TULSA METROPOLITAN AREA PLANNING COMMISSION

For Meeting No. 2516

June 4, 2008

BOATMENS BANK
Lot 1, Block 1
(Plat No. 5061)

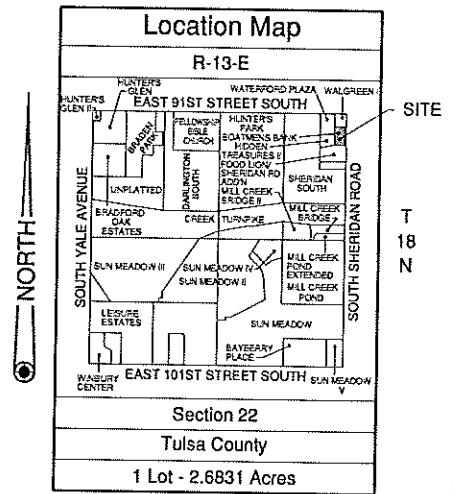
This application is made to allow a change of access along South Sheridan Road. The property is zoned PUD 206.

Staff recommends approval of the change of access. The Traffic Engineer has reviewed and approved the request. Staff recommends **APPROVAL** of the change of access as submitted.

5801 E. 41st
Site Plan, MTS

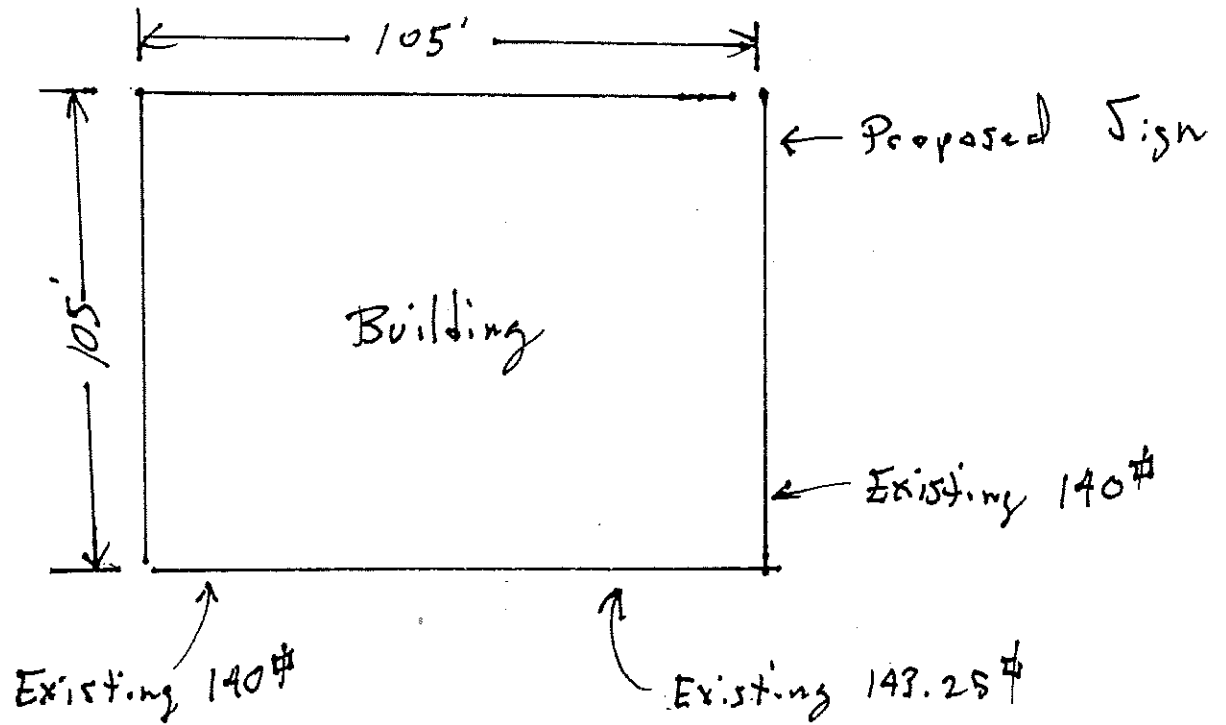
This request is seeking an over-all increase of 73.25 SF in display surface area (DSA) permitted on the east elevation only, from 210 SF, to 283.25 SF to allow for the installation of a 143.25 SF wall sign. There is an existing 140 SF wall sign on the east elevation. The underlying CS zoning on the lot would permit 630 SF of wall signs on the east elevation alone. The additional square footage is a .69 sf increase above the 2.0 SF of DSA permitted by section 1103-B, 2a of the Zoning Code.

On May 13, 2008 the City of Tulsa Board of Adjustment (BOA) approved case #20675, granting a "variance of 2 sq. ft. per lineal ft. of wall for a wall sign in a PUD from 210 to 335 sq. ft. to add an additional sign on the east elevation (Section 1221.D)" to permit this additional signage.

Because of the height of the building (ten stories, 125 feet) the approval of BOA case 20675, and the immediate surrounding areas staff finds this request to be minor in nature. Therefore, staff recommends **APPROVAL** of minor amendment request PUD-276-5 per the following conditions:

Per PUD-276-3, no new wall signs permitted on the north elevation of the subject building.

EXHIBIT A

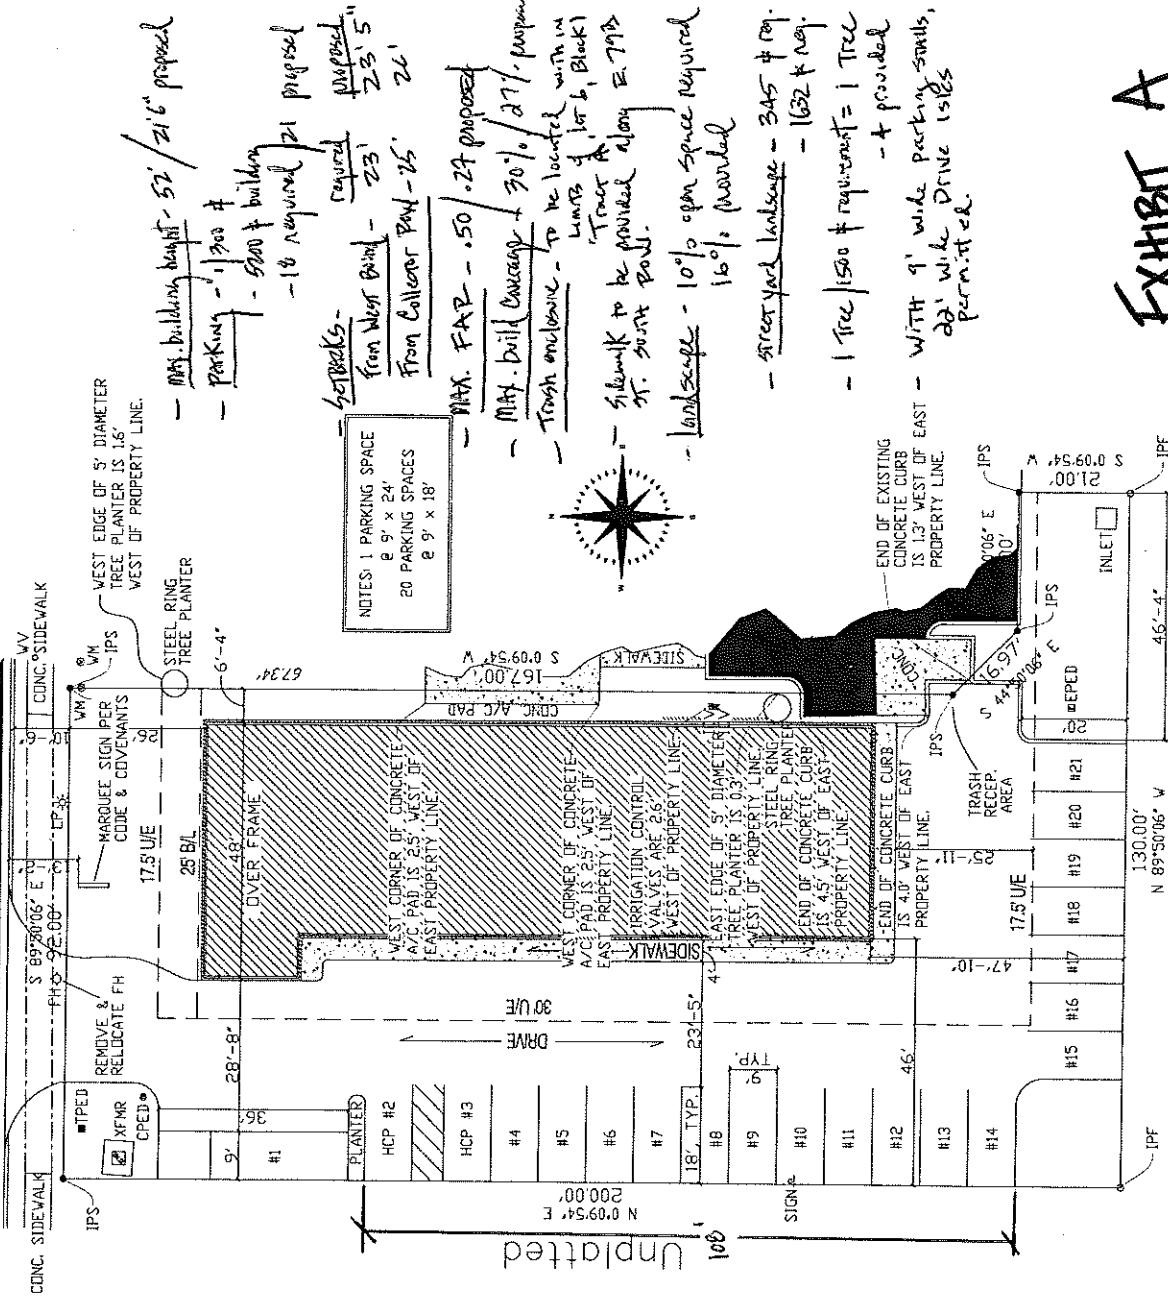
The submitted site plan meets all applicable building floor area, lot coverage, building height and setback limitations. Parking has been provided per the Zoning Code and a trash enclosure is provided per PUD standards. Landscaping is provided per the landscape chapter of the Zoning Code and adopted PUD development standards. Any proposed sight lighting must be directed down and away from adjoining properties per application of the Kennebunkport Formula and will be subject to a detail review.

Therefore, staff recommends **APPROVAL** of the detail site plan for Lot 6, Block 1 – Tract A – Tallgrass Office Park pending the receipt of revisions as requested and depicted on the enclosed Exhibit A.
